South Palm Canyon Drive Low Water Crossing (Bridge) Project City Project No. 06-18, Fed. No. NBIL(502)

April 9, 2025

12/17/19 Memo describes 4 Options as follows:

Figure 3: Option 2

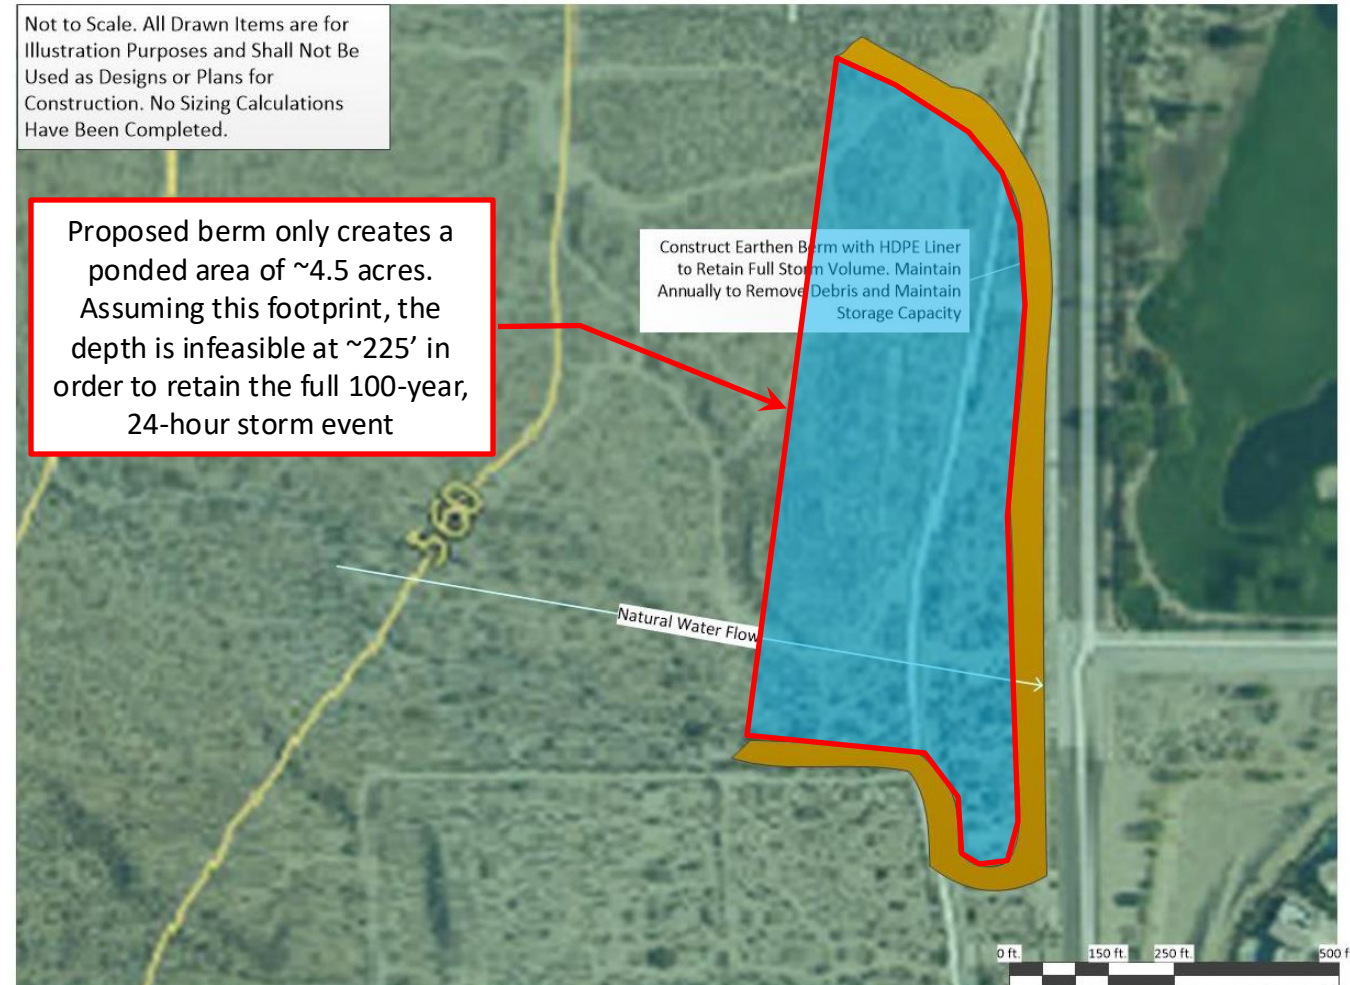
- Basin layout as shown is approx. 2,500ft long by approx. 50ft wide and would need to be about 46ft deep to hold 1,000 ac-ft. of water

Figure 5: Option 4

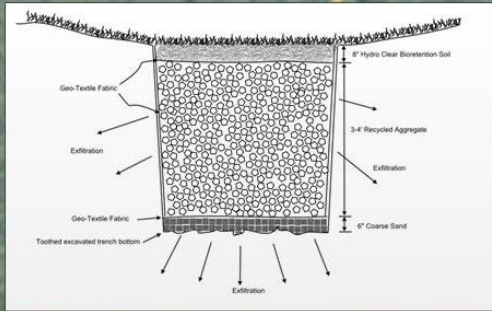
Infiltration trenches are typically no deeper than 8' and are better suited for smaller runoff volumes or for stormwater treatment, not retention of large storm volumes. An 8' deep infiltration trench may have a retention capacity of 240,000cf compared to approx. 43,560,000cf of runoff experienced at this location.

- The sediment basin would provide for additional storage capacity but would still be infeasible.
- After accounting for the added infiltration trench capacity, the debris basin would need to be approx. 435' deep in order to retain the full 100-year, 24-hour storm volume. (Not accounting for the reduction in available volume runoff due to sediment volumes)
